DELTRIN AF	LIGO UF DESIGN			
	EDM SPACER			
HINDMAN/BLAND	SIZE	FSCM NO.	DWG NO.	REV
2/26/2004			D000225-02-D	01
SCALE NTS		SHEET

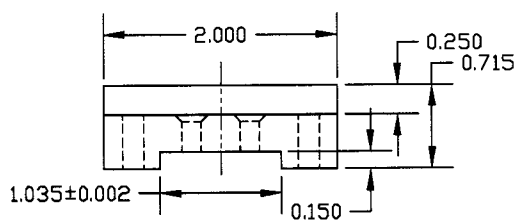
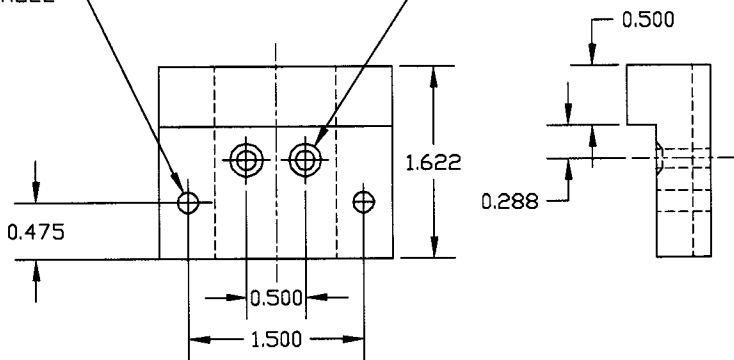
REVISIONS				
ZONE	REV	DESCRIPTION	DATE	APPROVED
	00	Initial DWG by UF Luke Williams	5/02/02	
	01	Revised by N. Hindman/B. Bland Thickness of spacer was too thin for proper counterboring. By removing the EDM base, this thickness can be increased as shown here.	2/26/04
